F/YR20/0167/O

Land north of The Barn, High Road, Bunkers Hill, Cambridgeshire

Erect up to 5x dwellings involving the formation of a new access (outline application with matters committed in respect of access)

Reason for Committee: Parish Council recommendation and number of representations contrary to the officer recommendation.

ESTABLISHED 1975		
Issue:		
Client: MR A. N. WHITE		
Drawing No: 2092-P1 SITE AND LOCATION PLAN		
Project: PROPOSED RESIDENTIAL DEVELOPMENT (OUTLINE)		
Site: LAND NORTH OF WILLOCK FARM BARN BUNKERS HILL		
Postcode: -	Drawn: DB	Checked: -
Print Scale: 1:1000	Date: 16-01-2020	Revision No: -

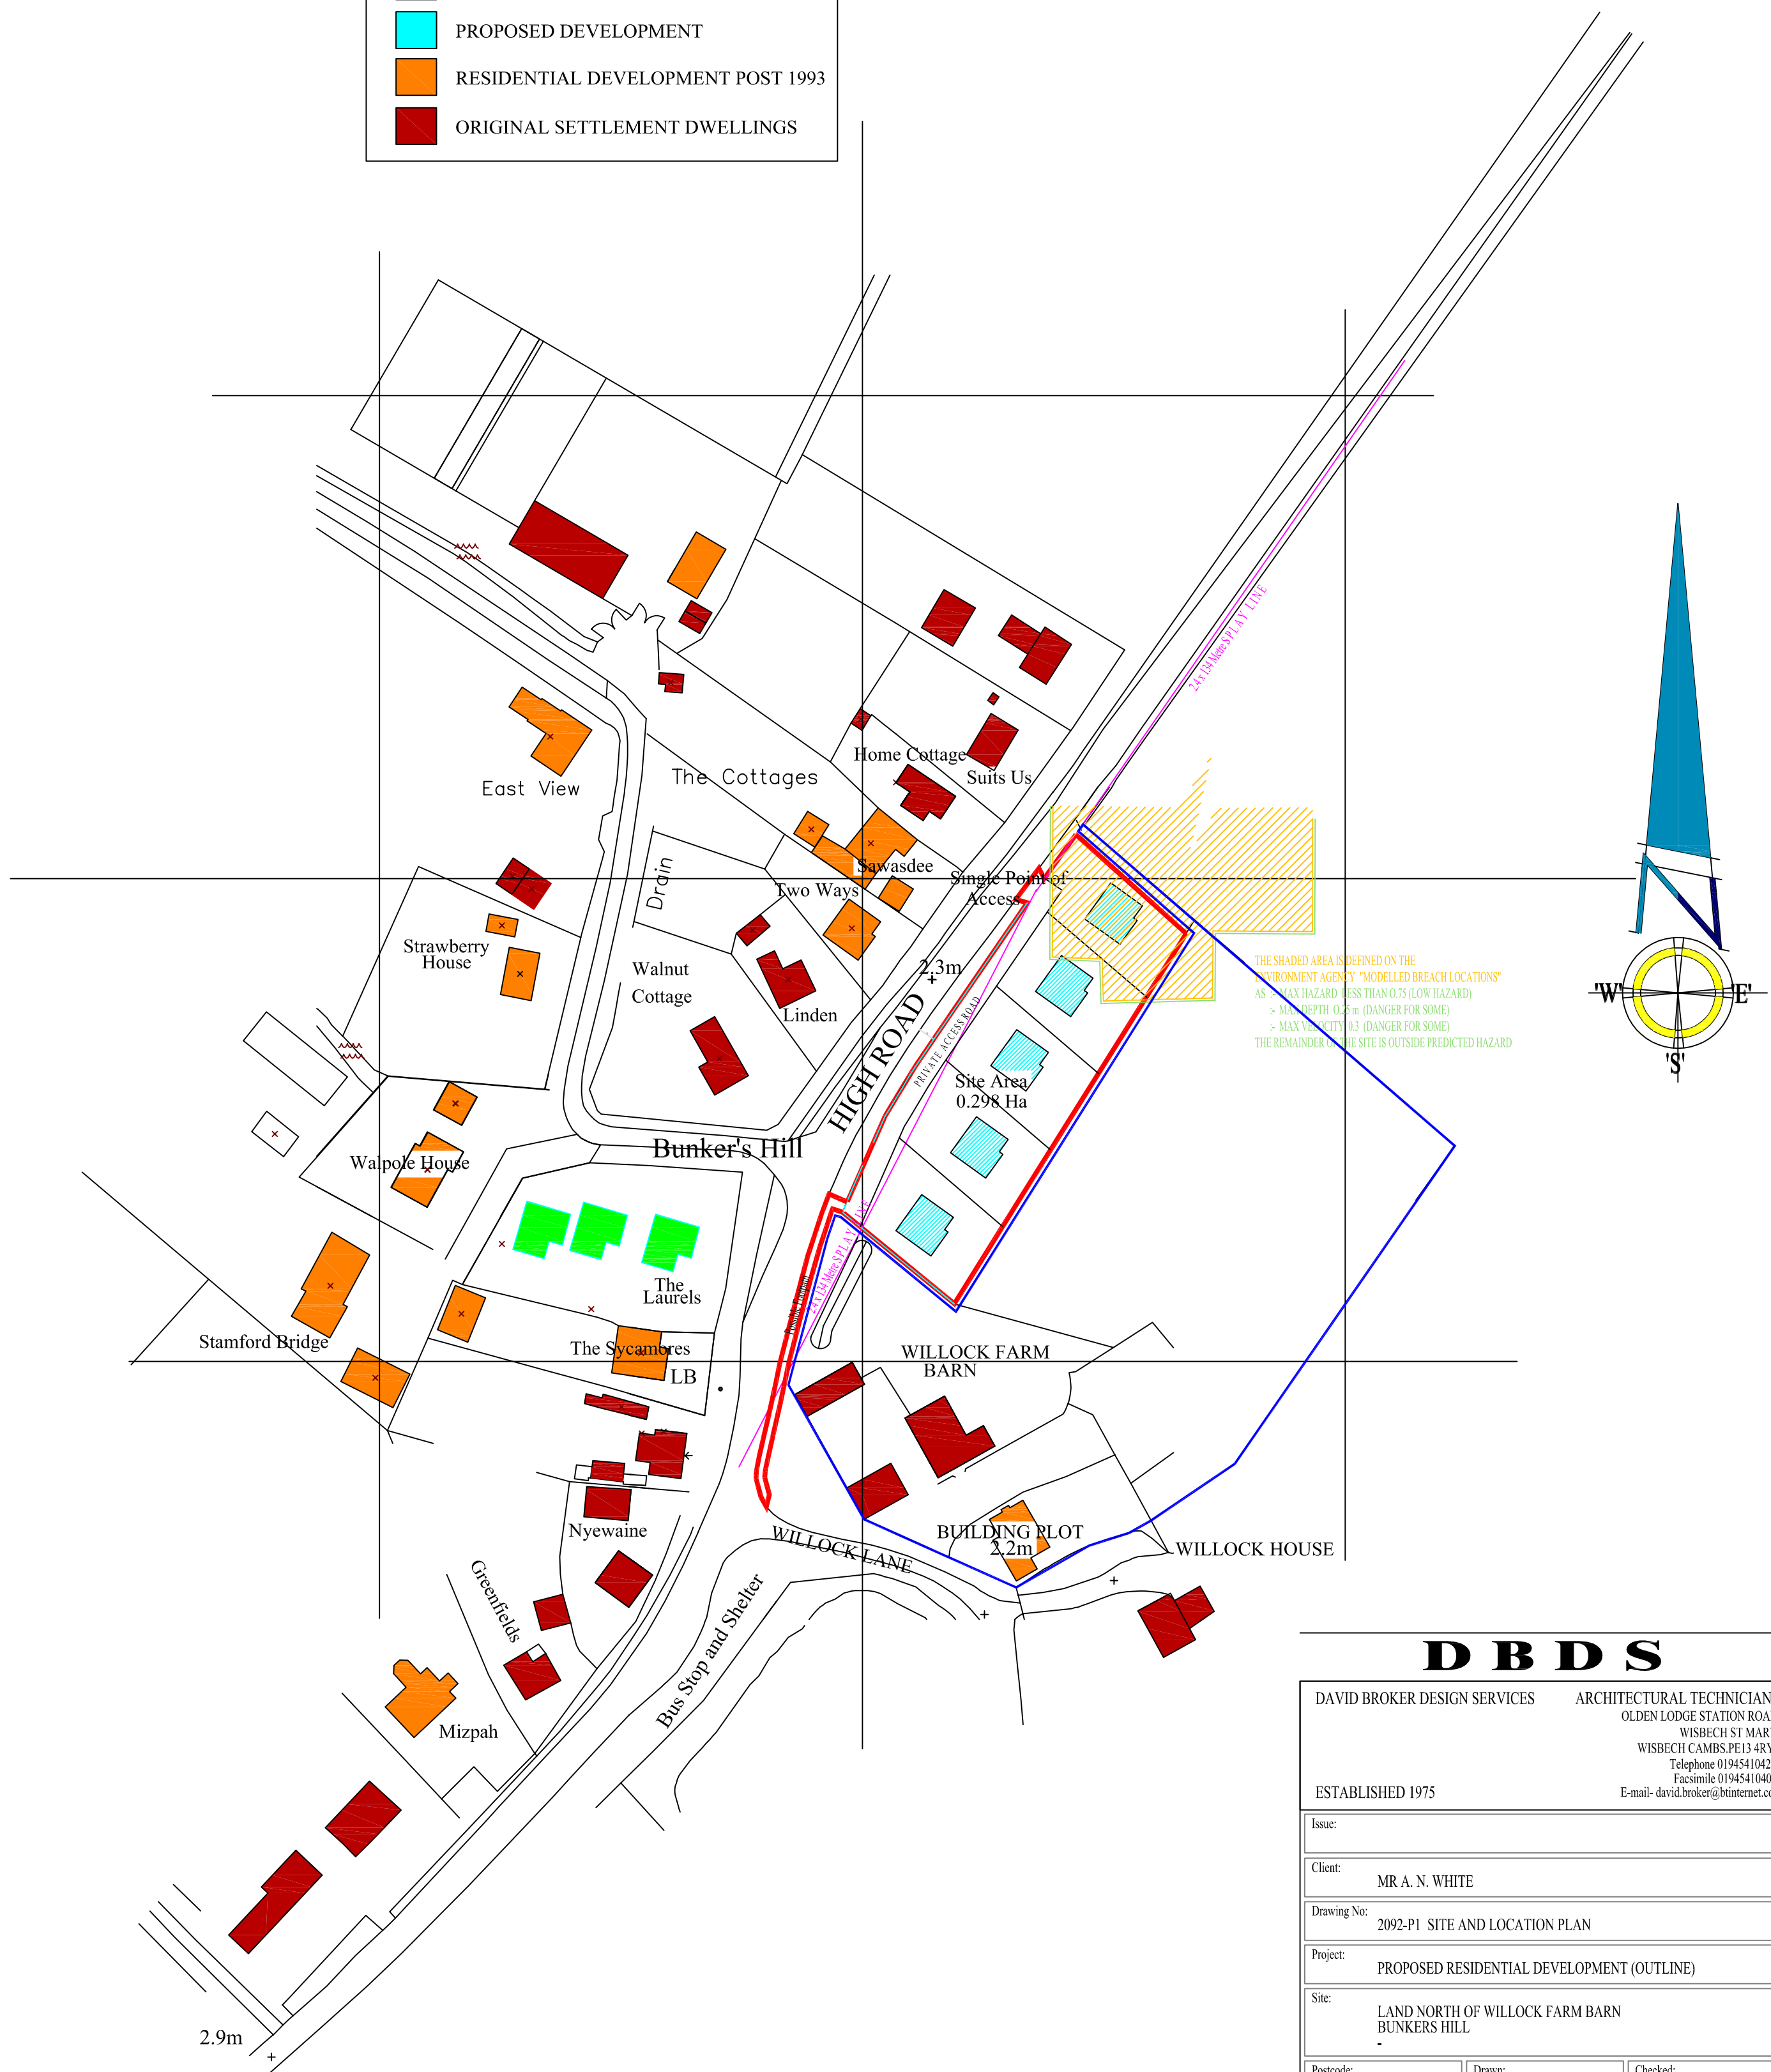
- 11.2. Insufficient details are provided of the proposed access geometry to the site to allow for a proper assessment of the suitability of that access for the scale of development proposed, in addition to the visibility splays associated with the point of access being incorrectly shown on the plans. The scheme therefore fails to demonstrate that it can achieve a safe and convenient access for all and would be contrary to policy LP15 of the Fenland Local Plan (2014).

<p>3. Policy LP15 requires development proposals to demonstrate that they can provide well-designed, safe and convenient access for all, giving priority to the needs of pedestrians, cyclists, people with impaired mobility and users of public transport. The application commits access, however the submitted plans do not provide any detailed access geometry, and the southern visibility splay is incorrectly drawn and therefore fails to demonstrate acceptable visibility and a safe access can be provided. The scheme is therefore contrary to policy LP15 of the Fenland Local Plan (2014).</p>
<p>4. Policy LP14 of the Fenland Local Plan (2014) and chapter 14 of the National Planning Policy Framework (2019) require residential development to be steered towards areas of lowest flood risk unless a sequential test identifies that there are no other suitable and reasonably available sites capable of accommodating the development. The proposal is located within flood zones 1, 2 and 3, and the scheme is not accompanied by a sequential test document indicating consideration of alternative sites. The proposal would therefore result in residential development within zones of higher flood risk without any justification indicating that the development could not be accommodated in areas of lower risk, and would therefore be contrary to policy LP14 of the Fenland Local Plan (2014) and chapter 14 of the National Planning Policy Framework (2019).</p>
